寄件者: AI TSANG <[redacted]>
寄件日期: 2026年10月05日星期一 14:29
收件者: Adrian Tsz Hin TAM/PLAND
主旨: TKLN 143 response TD and LD and clarification
附件: 143 response to td comment (2).pdf; 143 response to LD comment.pdf

Response to LD comment

Traffic impact proposal

1.1. The project site is submitted S16 Planning Application for proposed Temporary Eating Place and Green Fuel Station with Ancillary Facilities for a Period of 3 Years.

Swept Path Plan

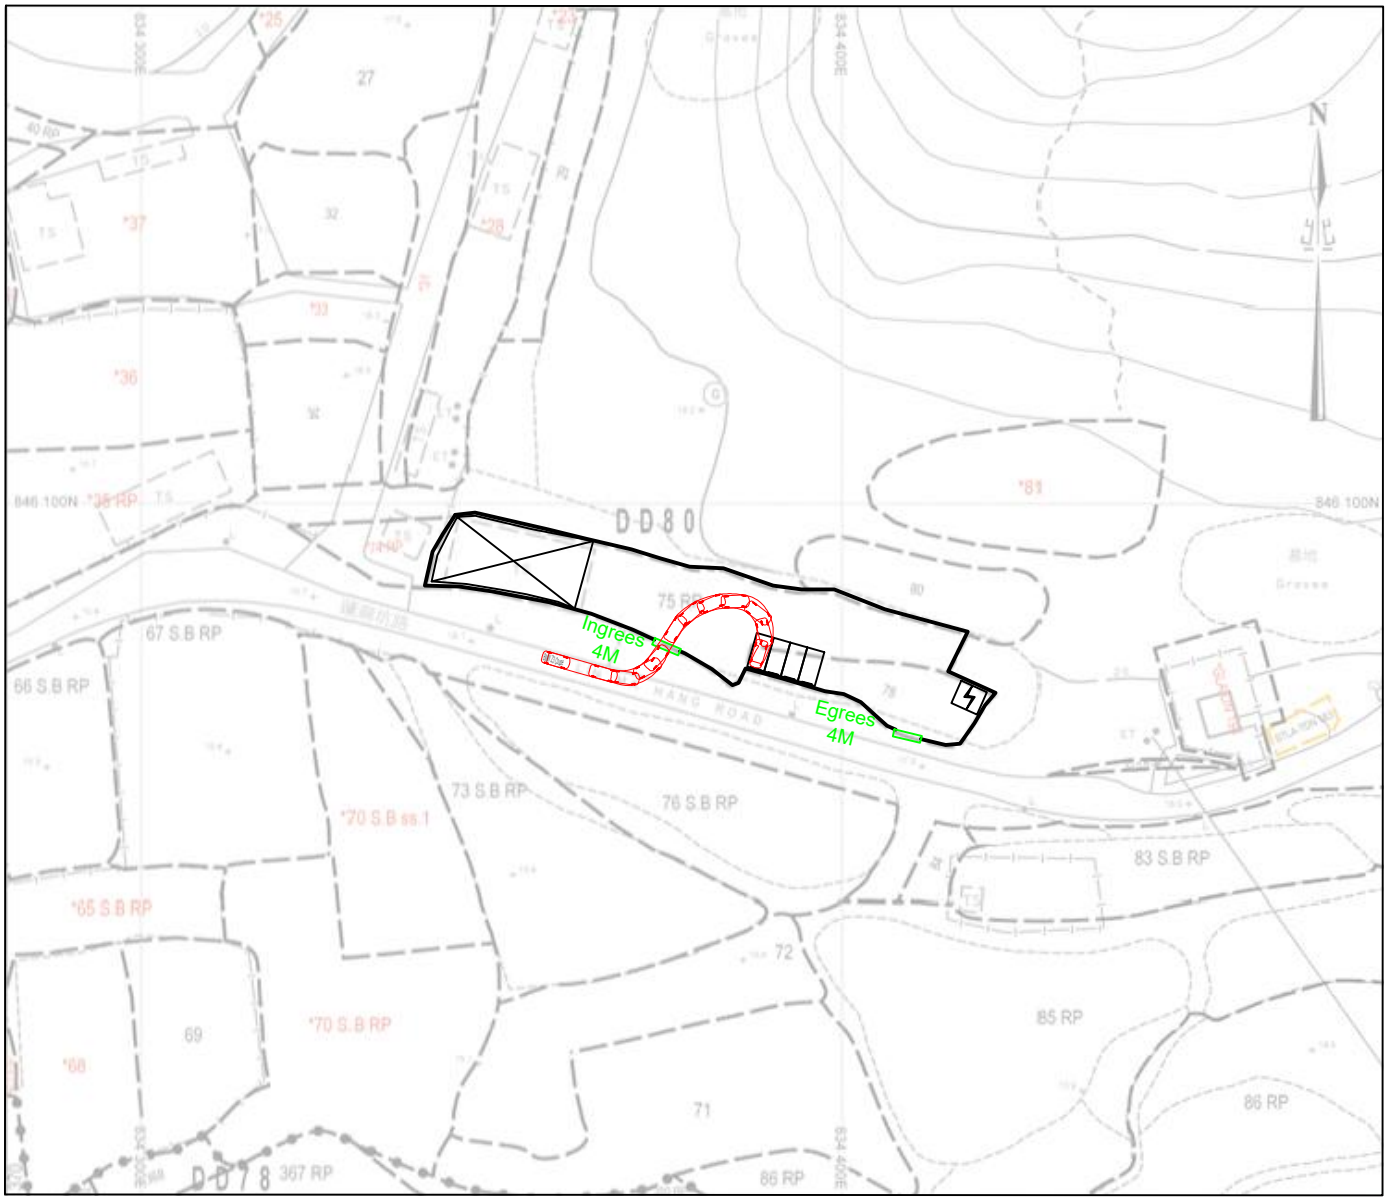
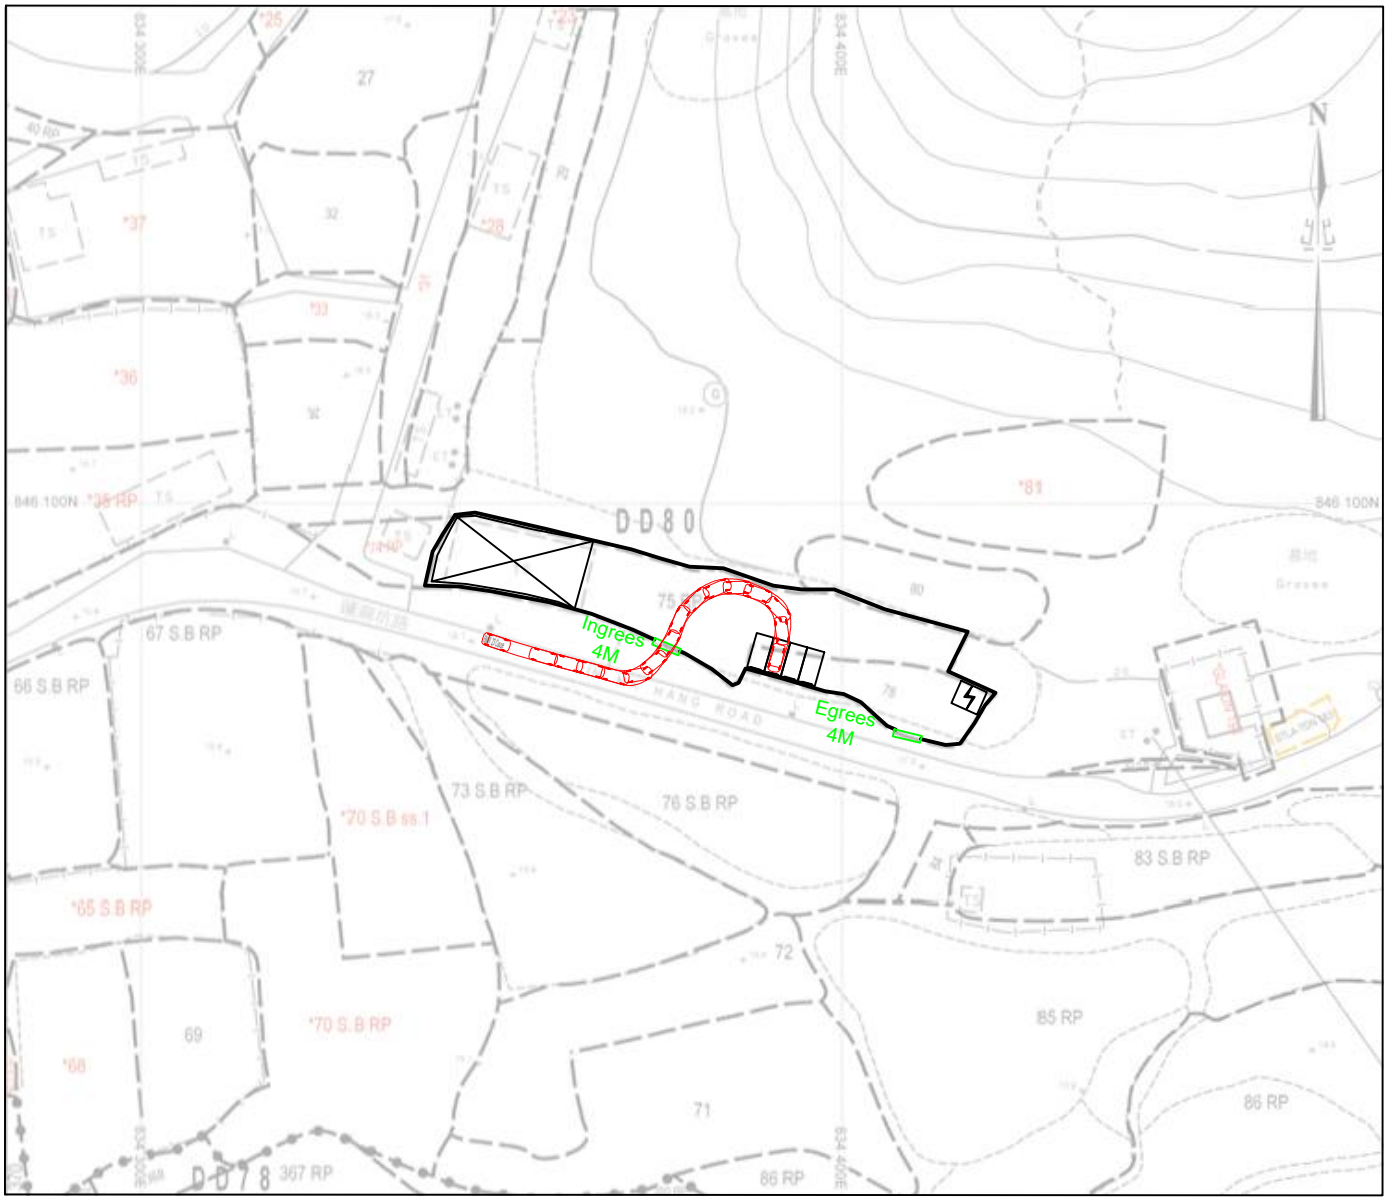
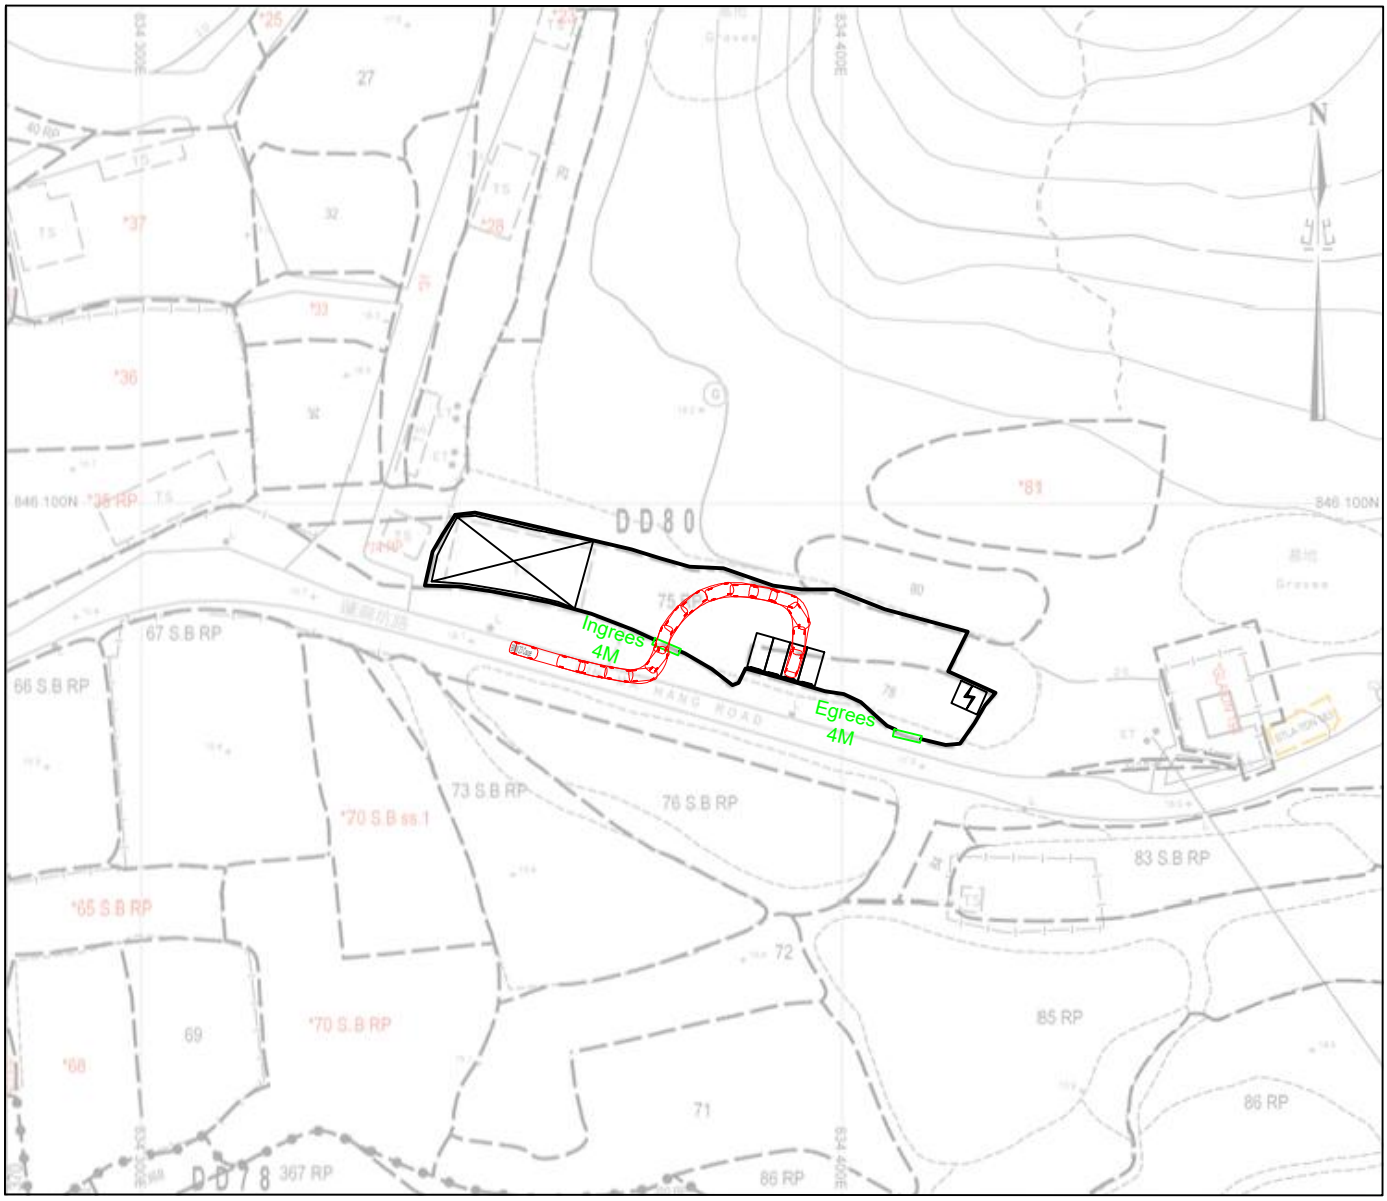
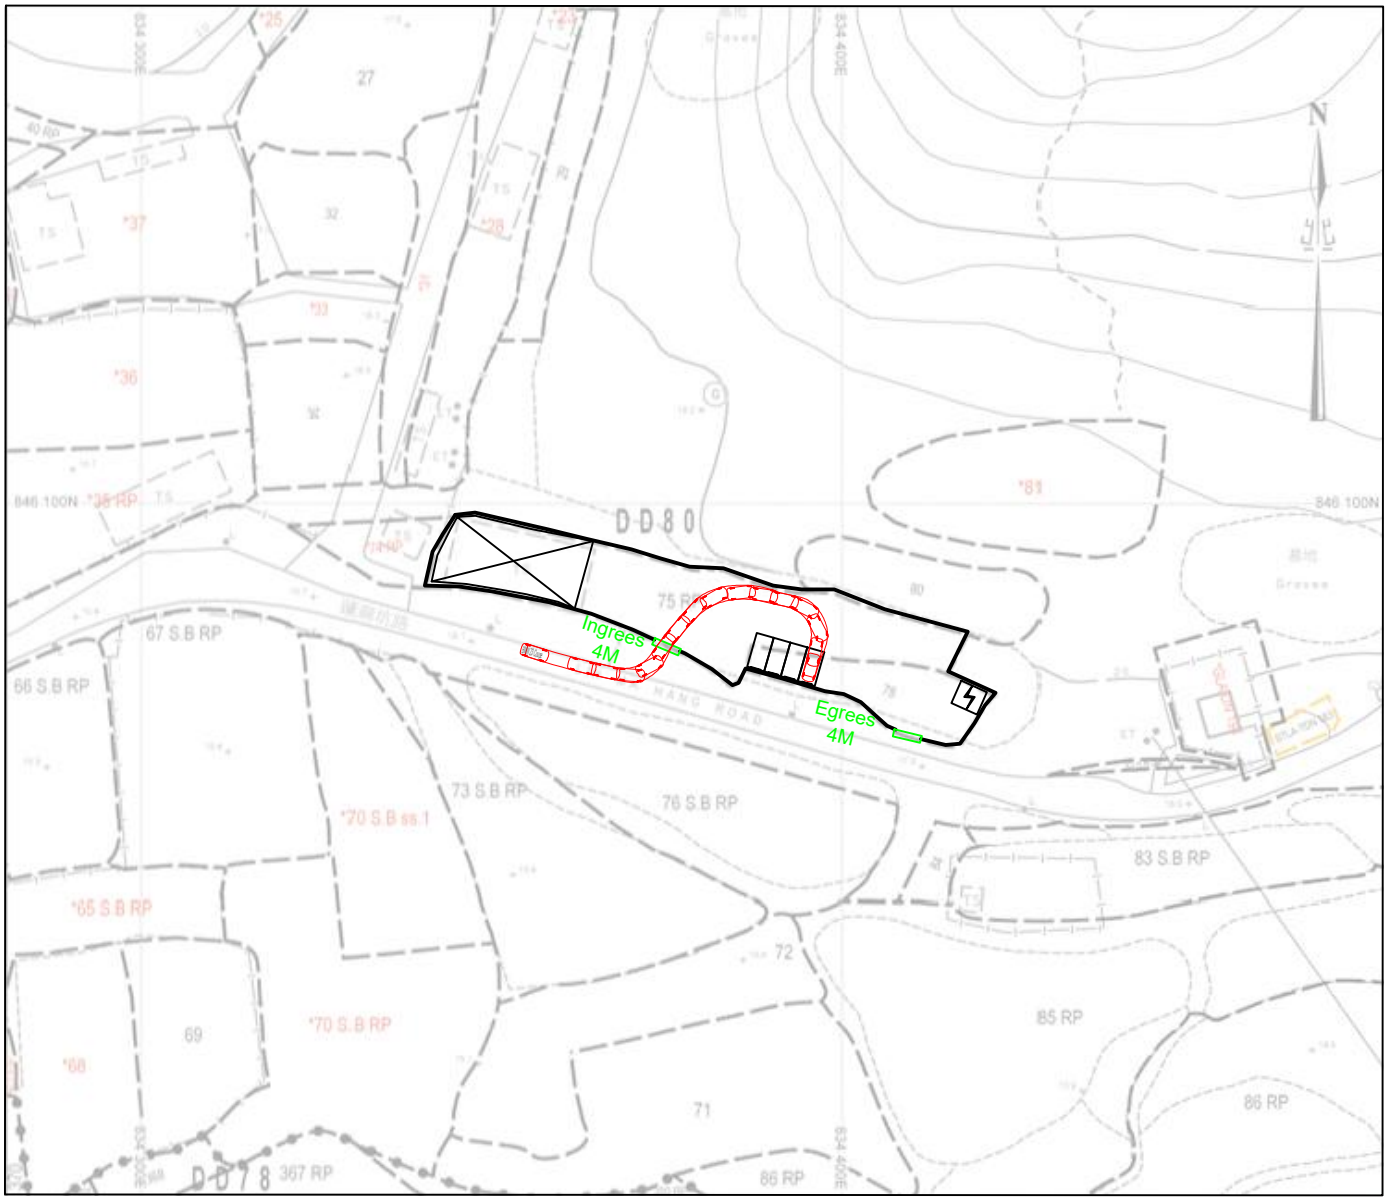
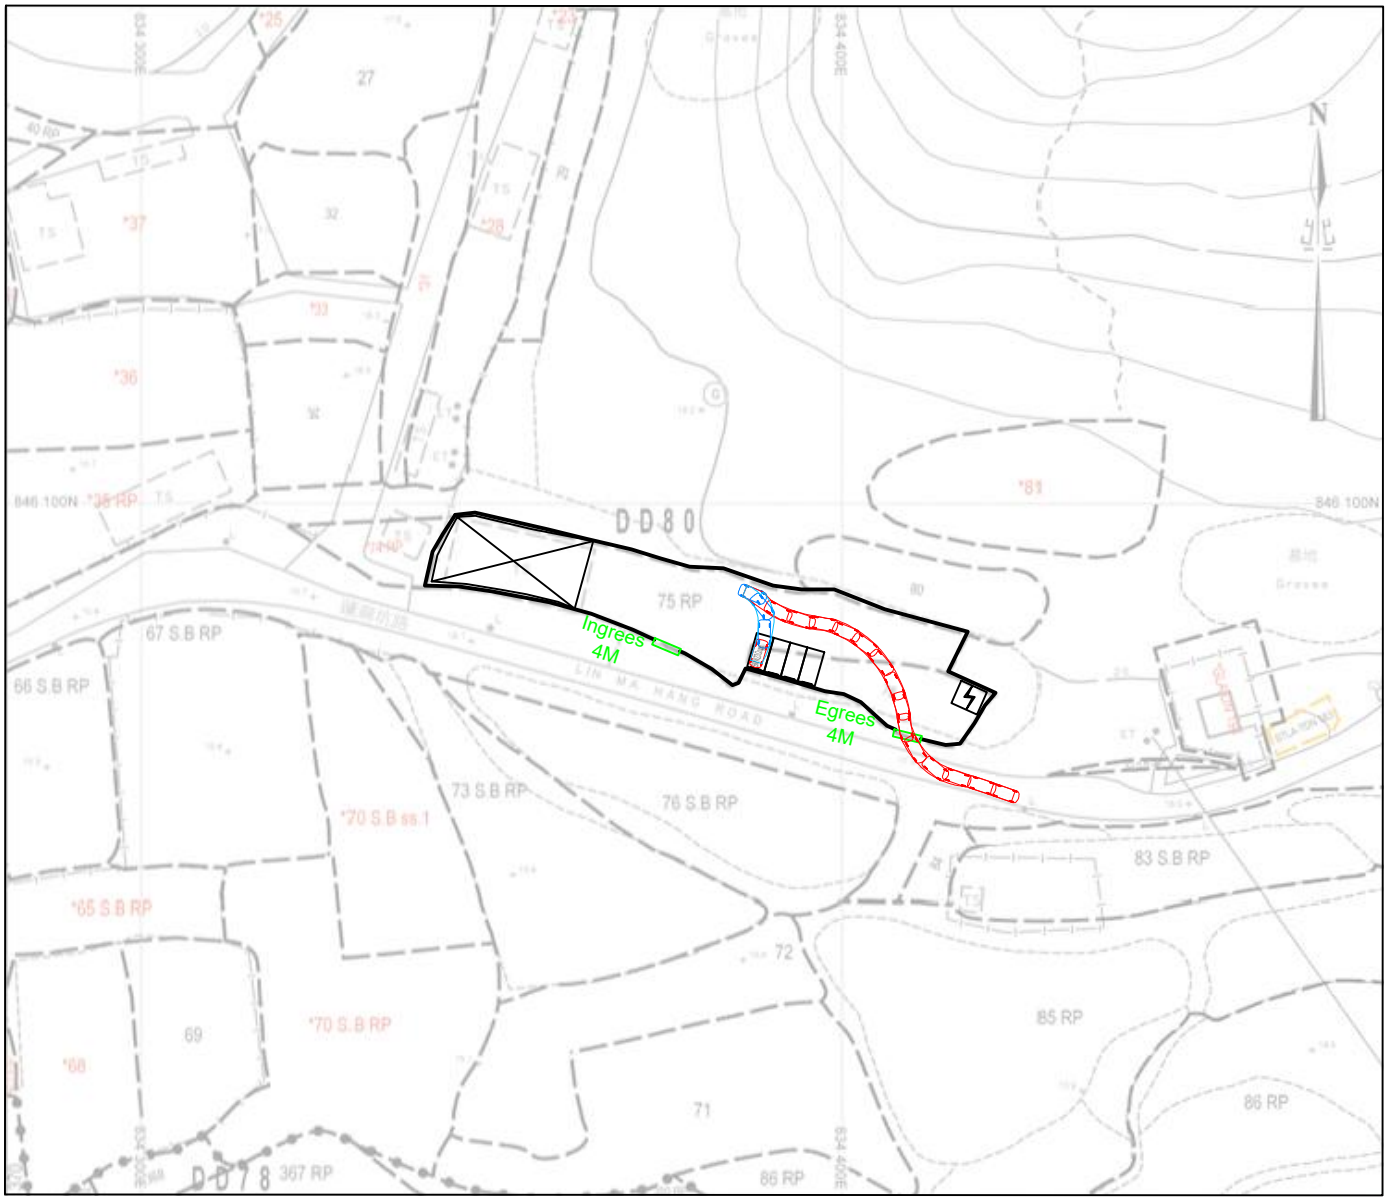
Comment 3
the applicant shall demonstrate the satisfactory maneuvering of the vehicles entering and exiting the application site, maneuvering within the application site and into/out of the parking preferably using the swept path analysis; and
Response
Please refer to swept path plan

1.4. Swept Path Analysis has been conducted for the access points and passages. The site access points and parking arrangements are sufficient for safe maneuvering and operation.
